INDEPENDENT REVIEW OF THE DRAFT WORK PLAN–RADIOLOGICAL SURVEY AND SAMPLING, FEBRUARY 2018  
FORMER HUNTERS POINT NAVAL SHIPYARD  
SAN FRANCISCO, CALIFORNIA

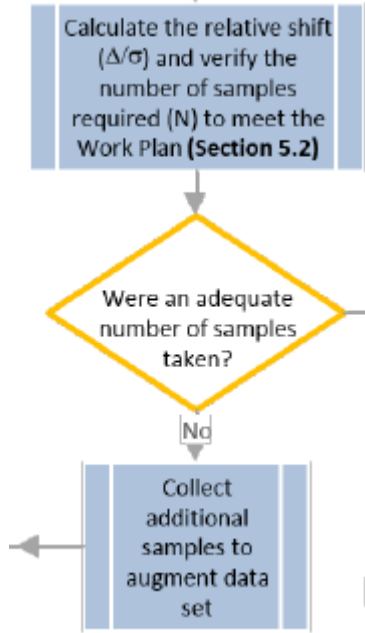
5.2.1.1	5-2	2nd	<i>A minimum of 18 surface sample locations will be identified on a random-start systematic grid.</i>	<p><b>Minor Comment:</b> The December 2017 preliminary work plan file figures that were provided as examples showed rectangular grid, recommend triangular if the units are sized appropriately. Triangular spacing provides an increased probability of locating anomalies that may be present, in particular for subsurface areas or where the durable cover will not be removed and scan sensitivity is limited, at best.</p>
